Item 01 - GA Elevation update

NORTH ELEVATION UPDATE OVERVIEW

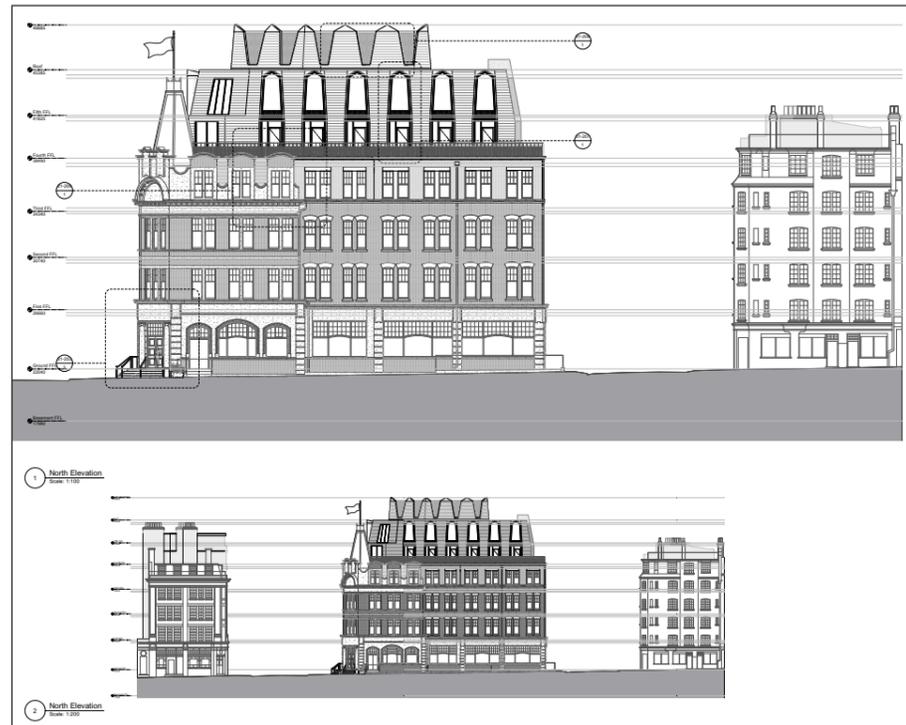
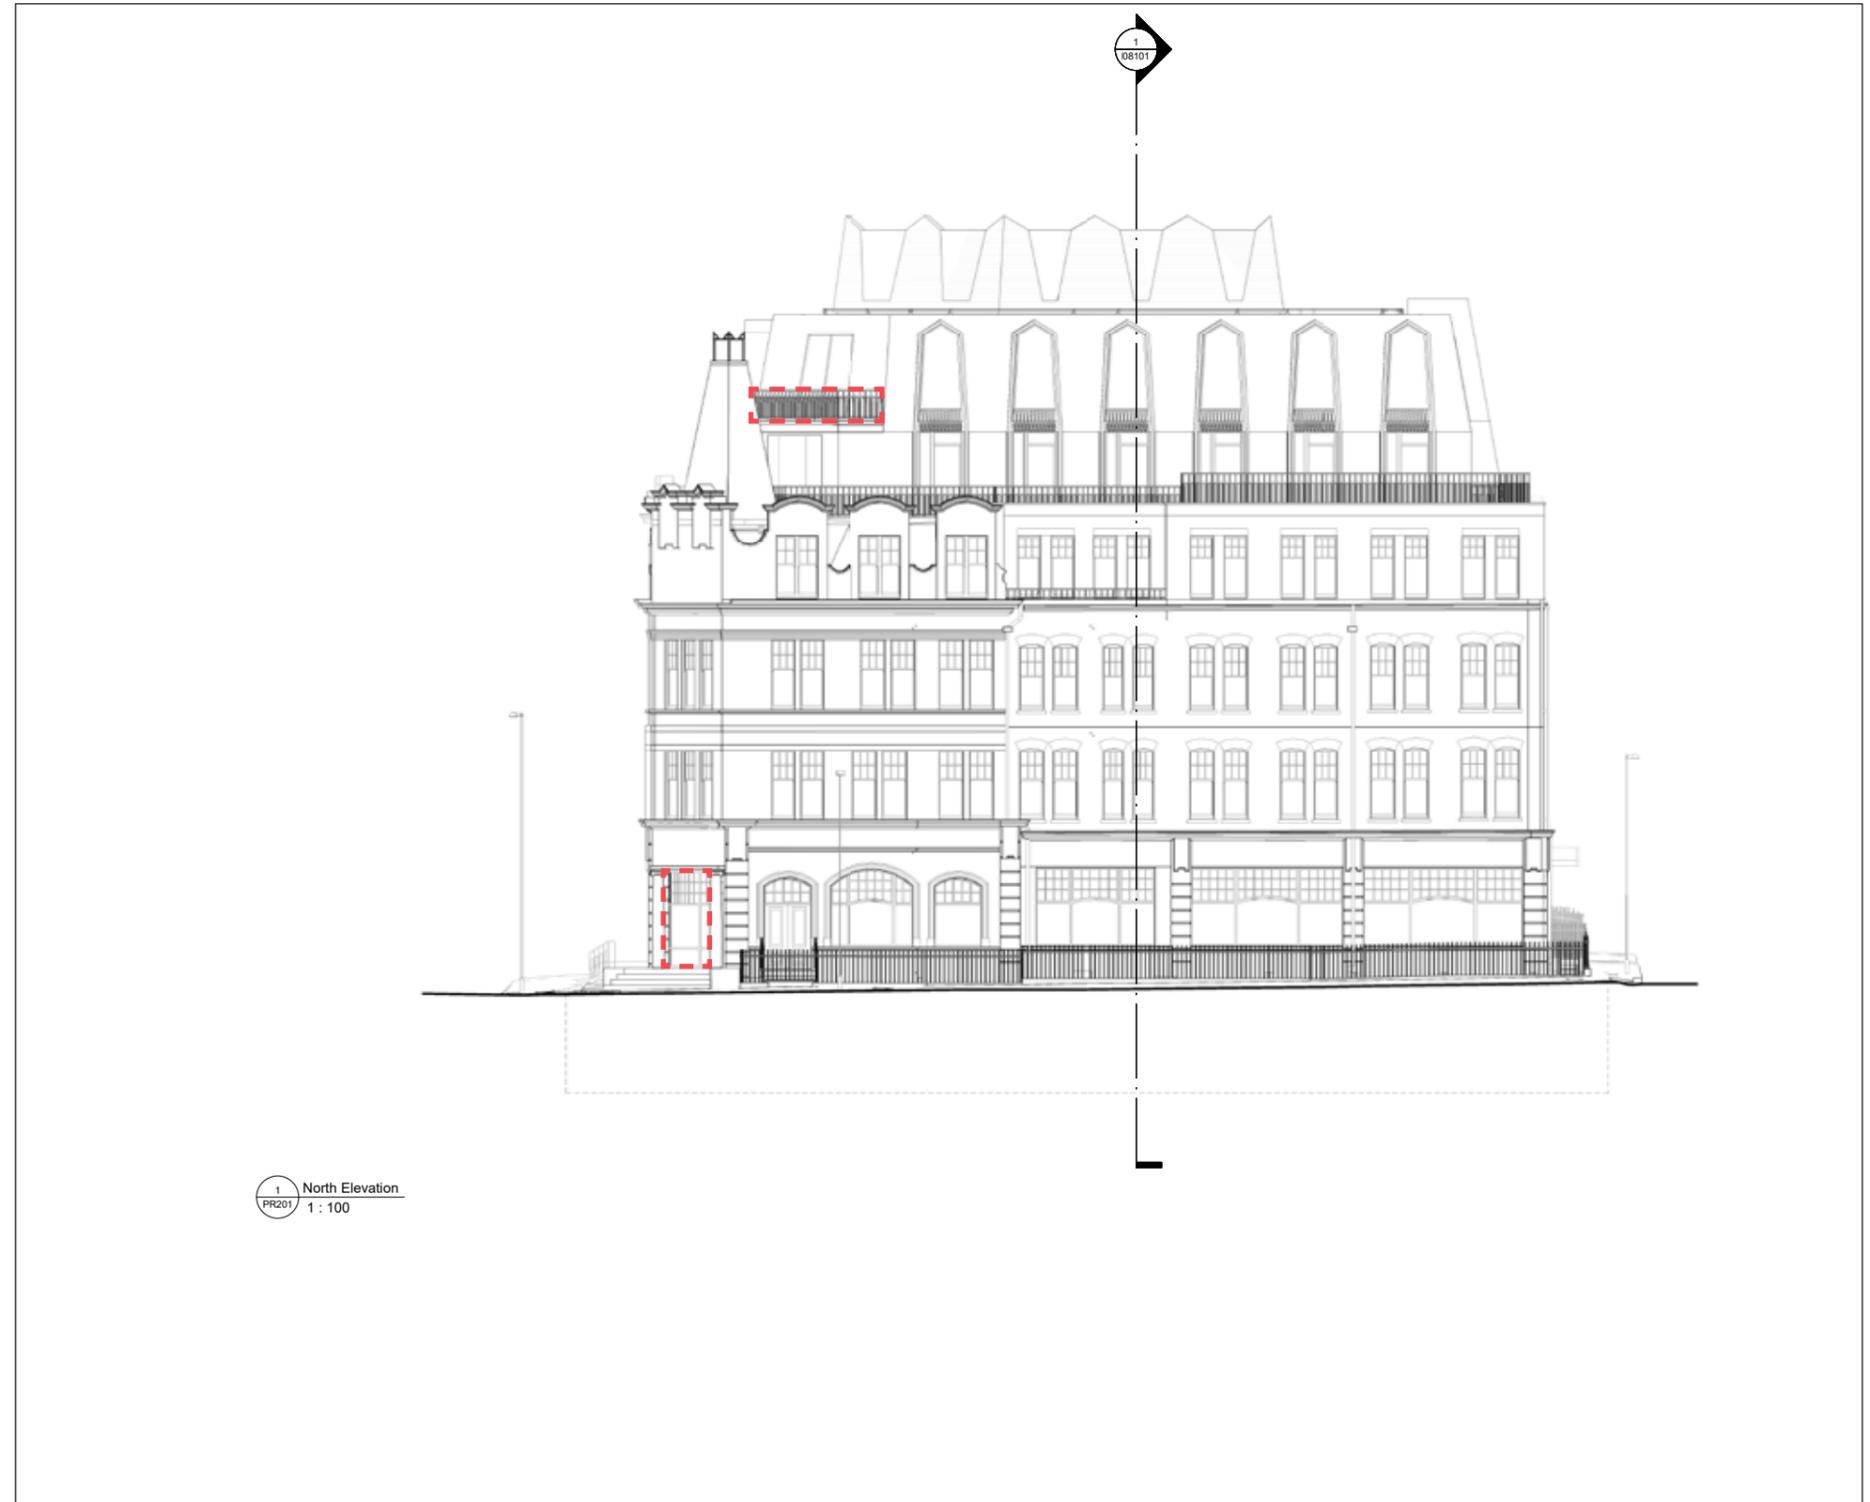
- + North East corner balustrade to flat roof
- + Omission of proposed new doors on ground floor at North East corner

SOUTH ELEVATION UPDATE OVERVIEW

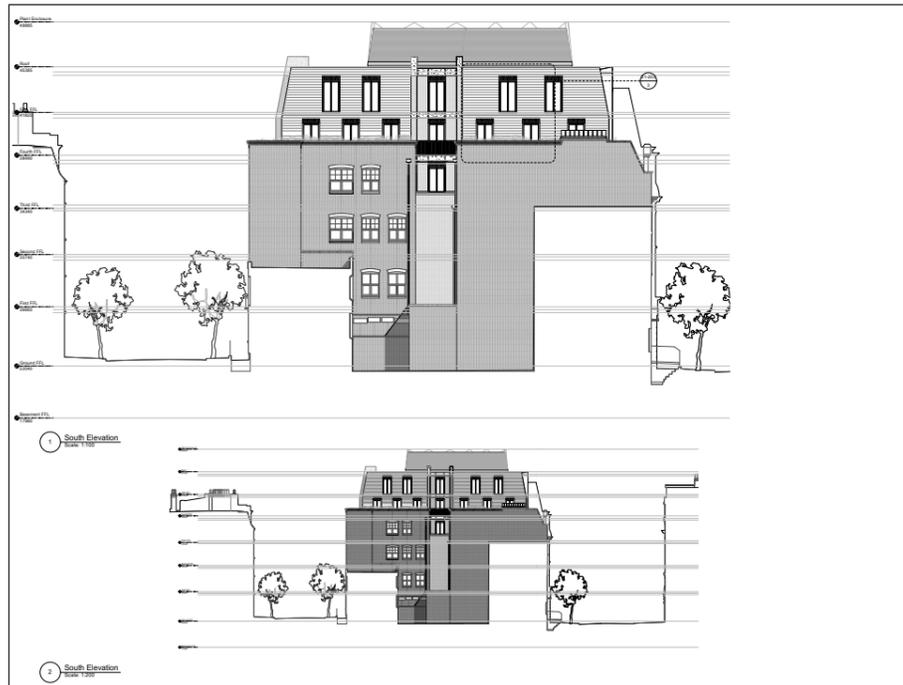
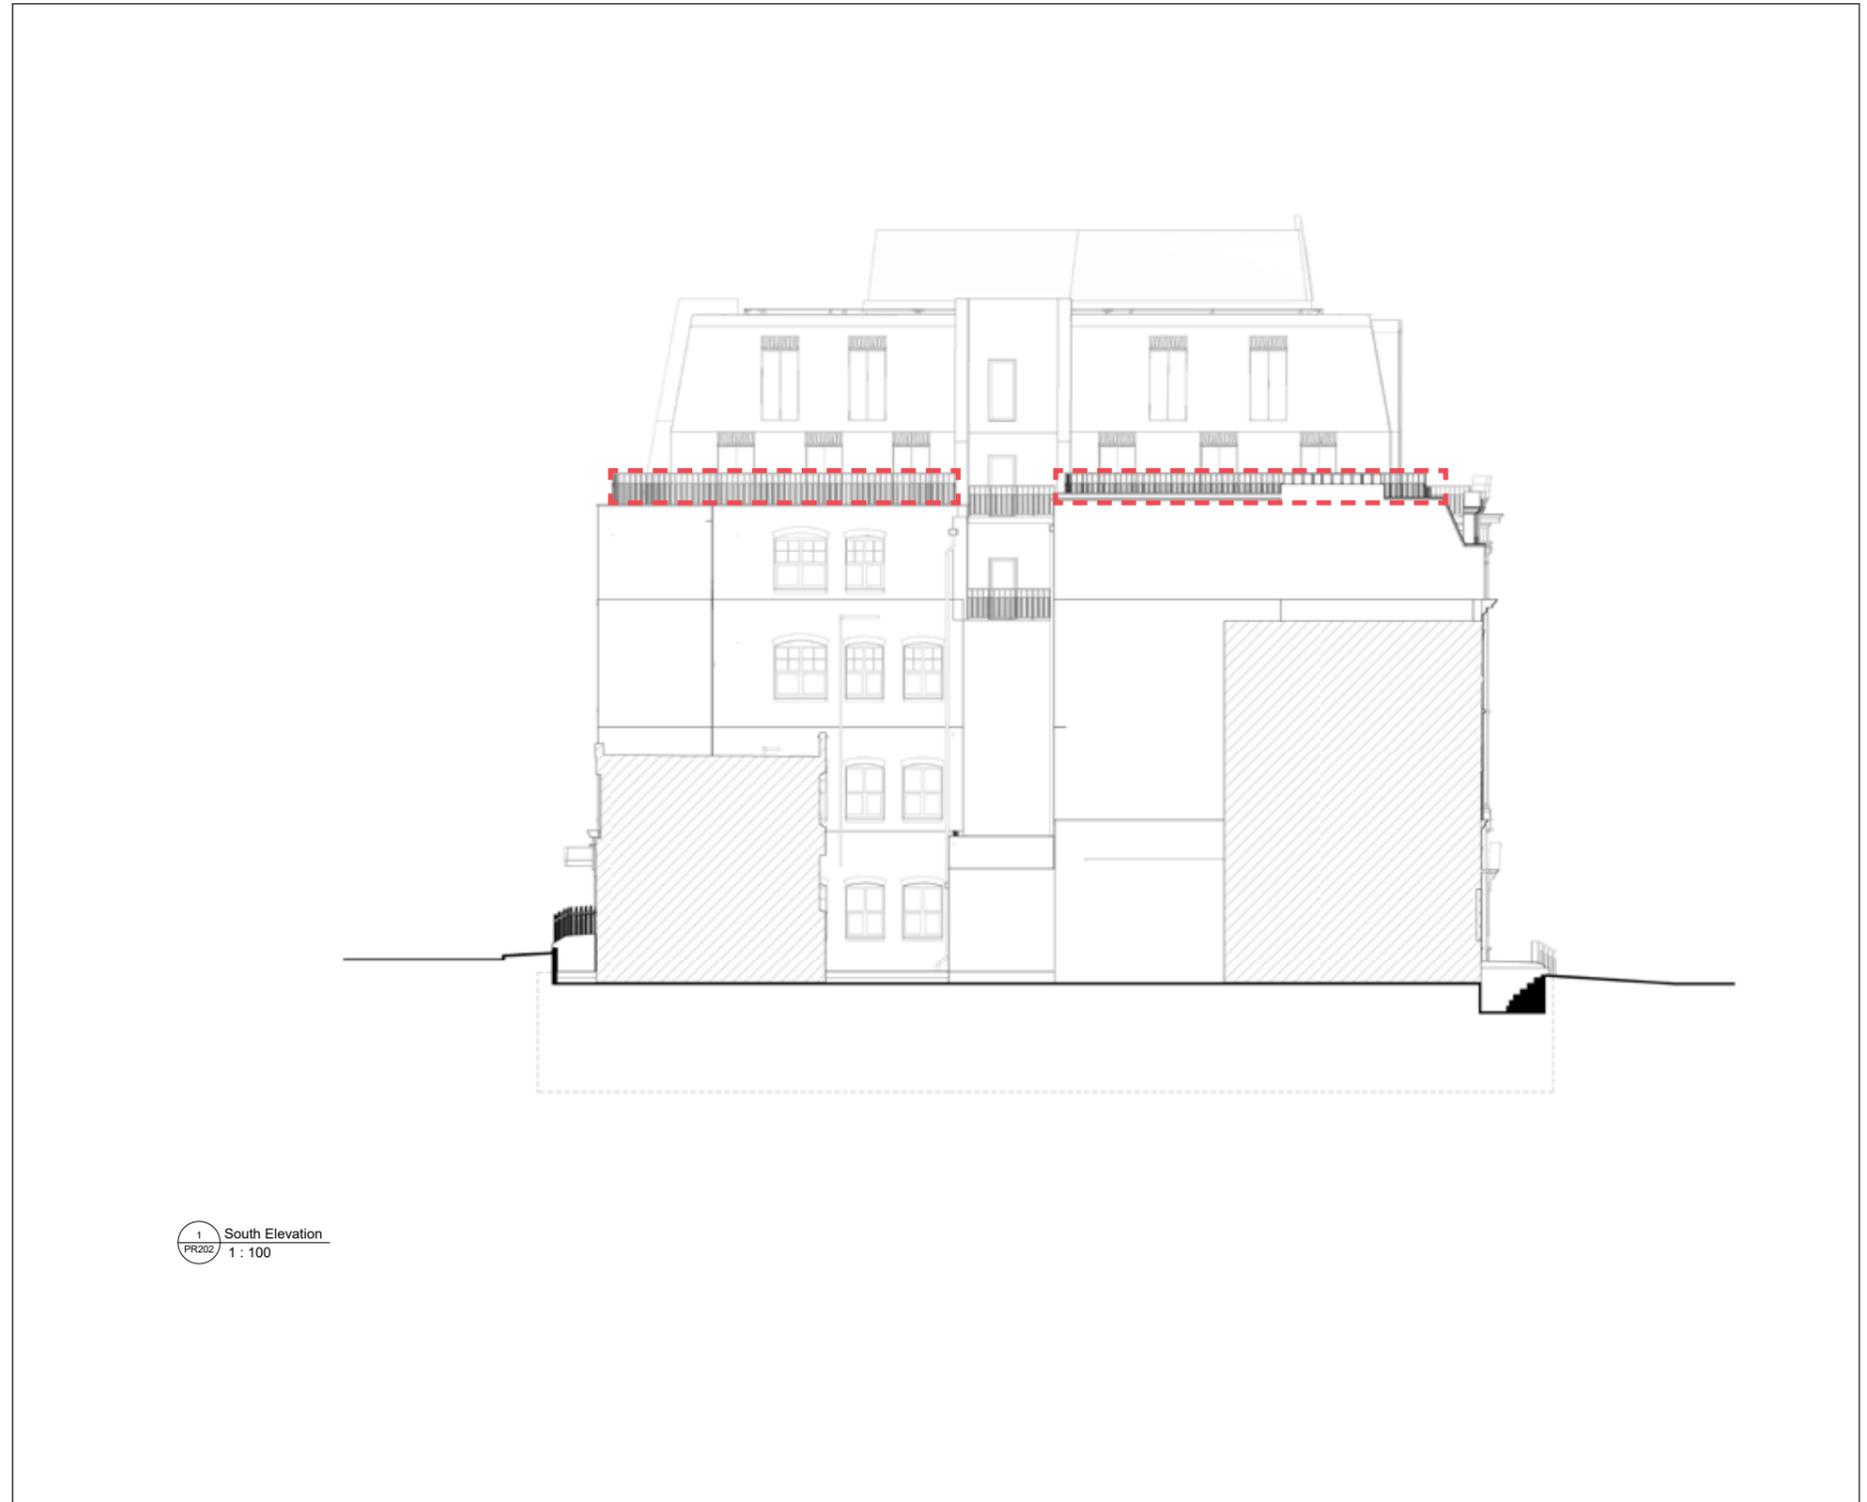
- + Height of South elevations brick parapets rationalised
- + Existing South East corner chimney stack remains at existing level - previous intent to raise elevation omitted
- + Height of balustrades adjusted for edge protection compliance

EAST ELEVATION UPDATE OVERVIEW

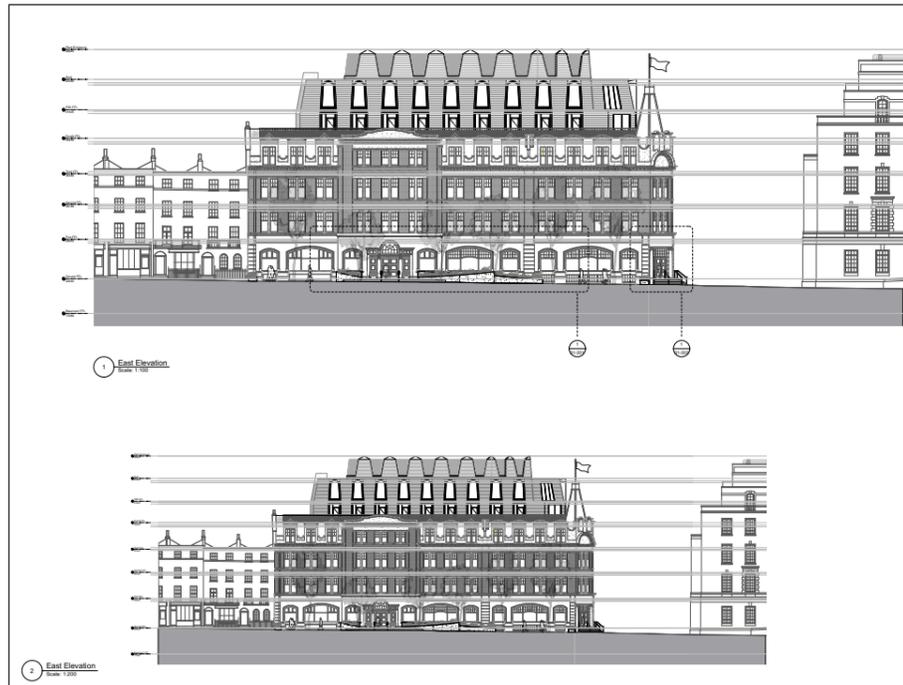
- + North East corner balustrade to flat roof
- + Omission of proposed new doors on ground floor level at East corner
- + Extended main entrance plinth along South East elevation for improvement of accessibility for external cafe amenity
- + New low level louvres under 3 existing windows for basement services ductwork. Relocated from the reception facade.

WEST ELEVATION UPDATE OVERVIEW

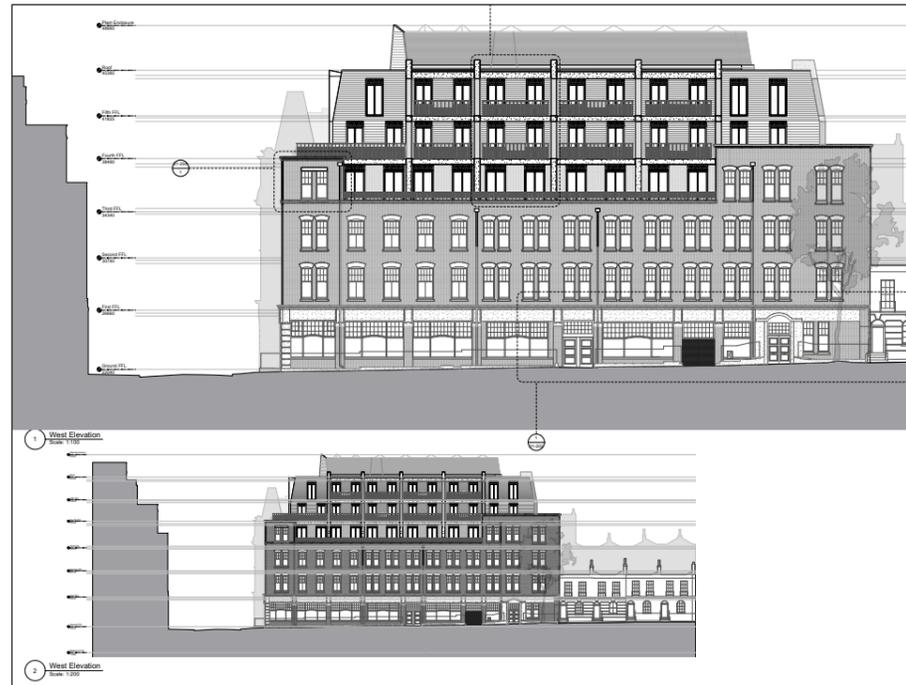
- + Height of South and South West corner elevations brick parapets rationalised
- + Height of balustrades adjusted for edge protection compliance

ADDITIONAL NORTH & EAST LOWER GROUND FLOOR ELEVATIONS

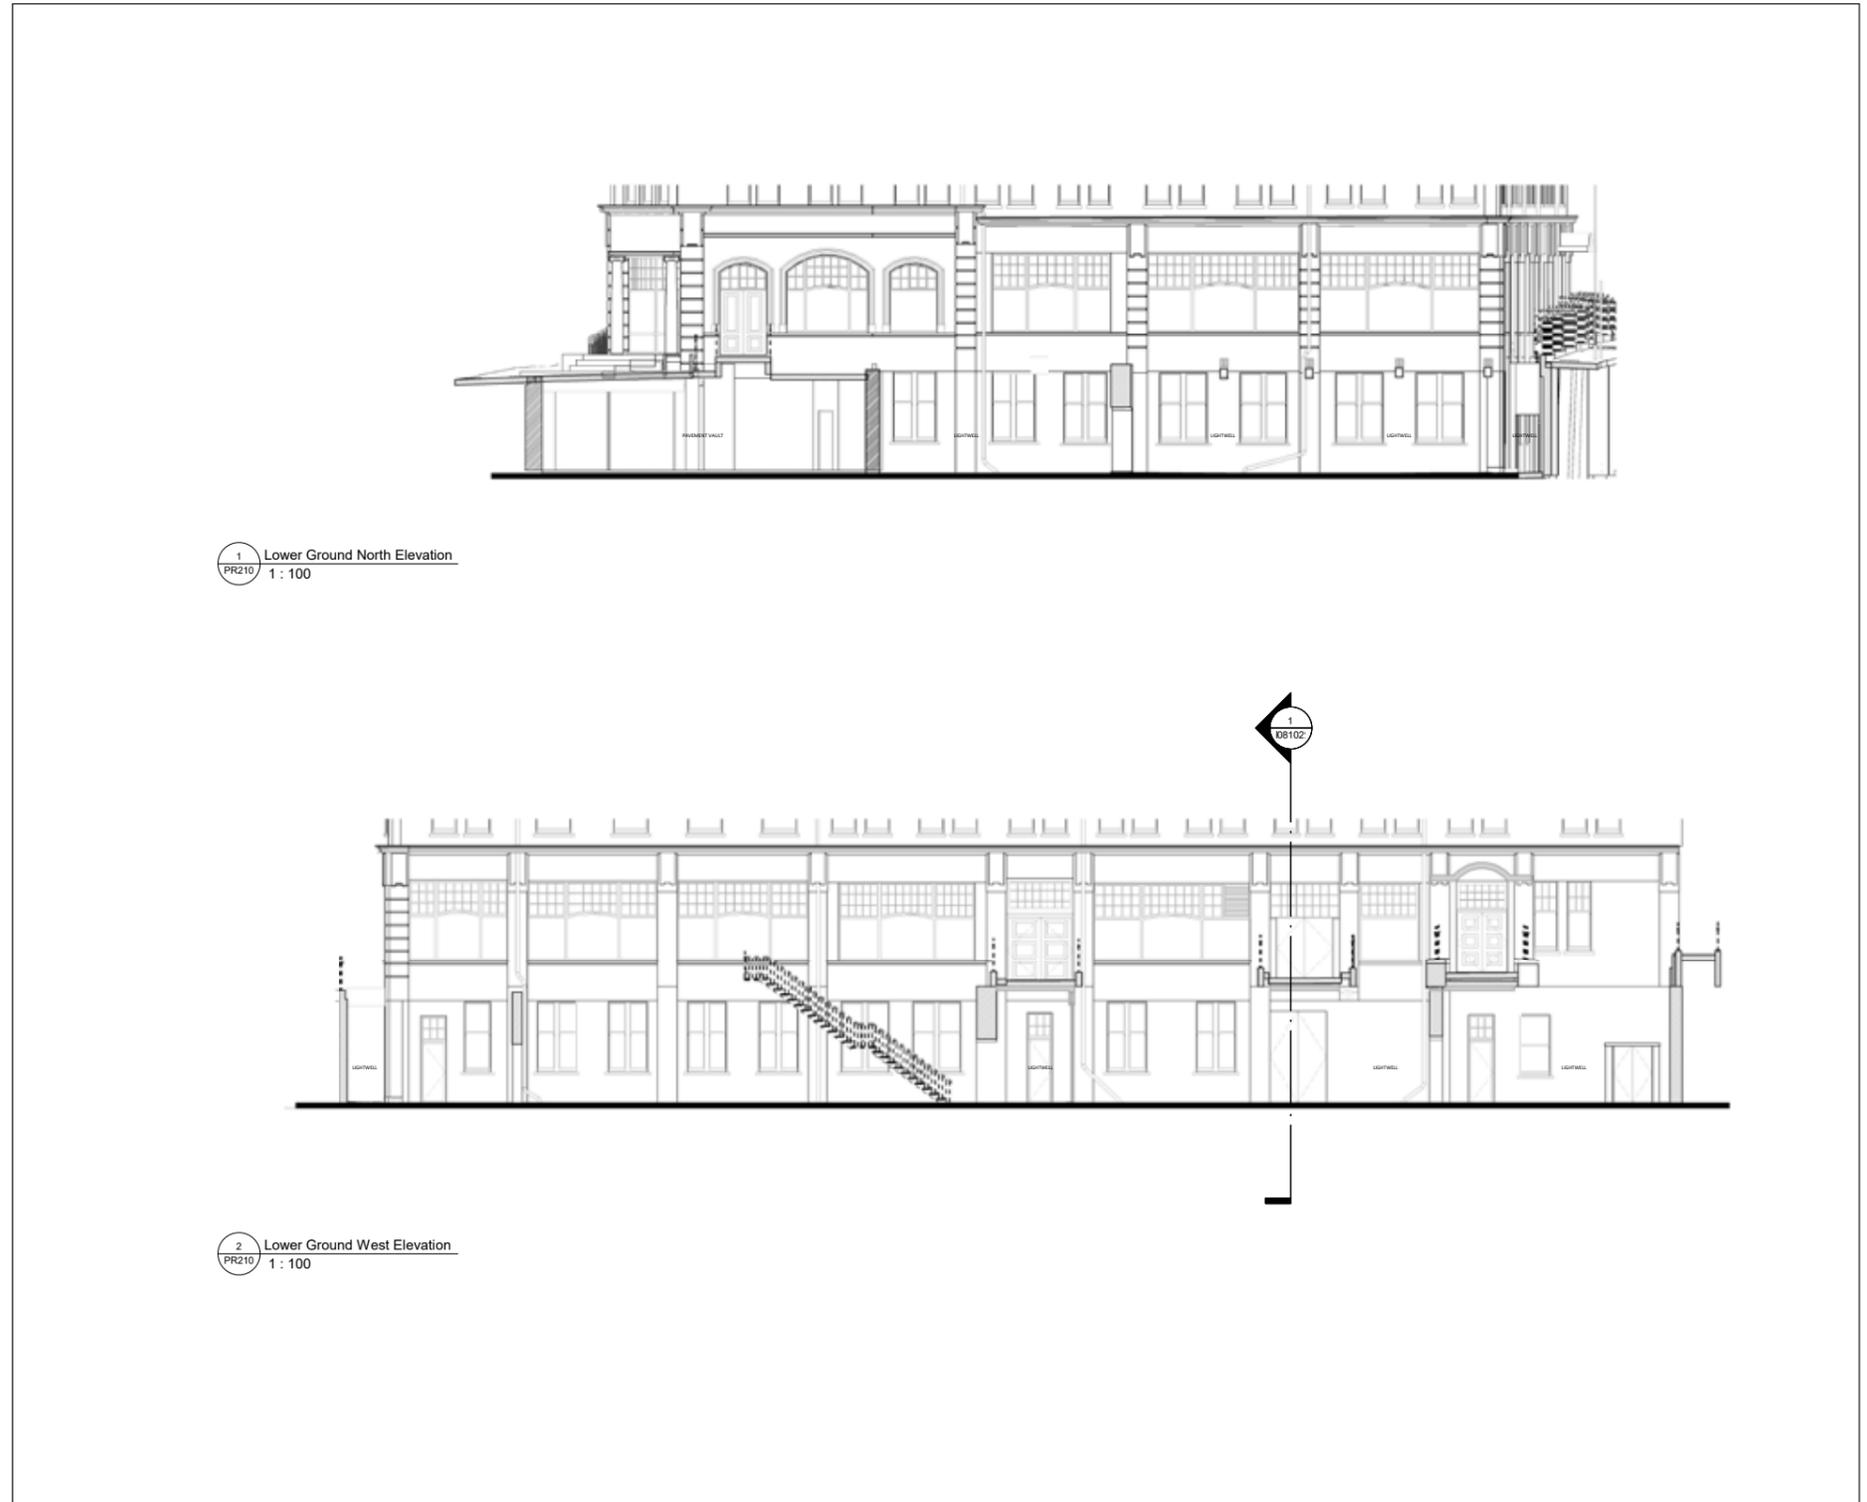
+ Additional elevations provided for further clarity of arrangements in lower ground floor lightwell
